Re: Government Review Comments of MCB Camp Lejeune Risk
Assessment Report for Hadnot Point

LANTDIV REVIEW COMMENTS

OF ESE RISK ASSESSMENT REPORT FOR HADNOT POINT

HADNOT POINT INDUSTRIAL AREA
BASELINE RISK ASSESSMENT

Figure 3-3
 REGIONAL CLIMATIC CONDITIONS
 CAMP LEJEUNE
 SOURCE: CNAVFACEGCOM, 1975

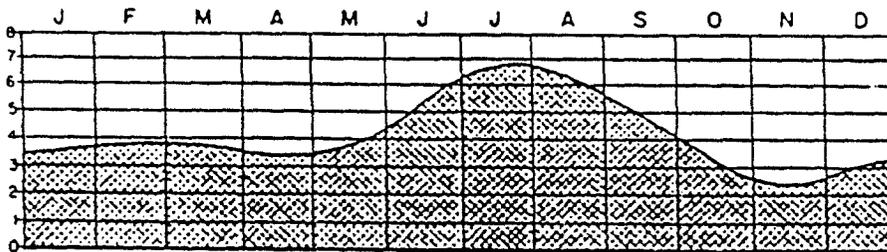
Why state it in centimeters here & show it in inches on Table 3-1. Please be consistent.

units?

Based on what? In Sect. 3.2.1.7 it states A21, 953. Numbers don't appear to correspond with those in Sect. 3.2.1.7.
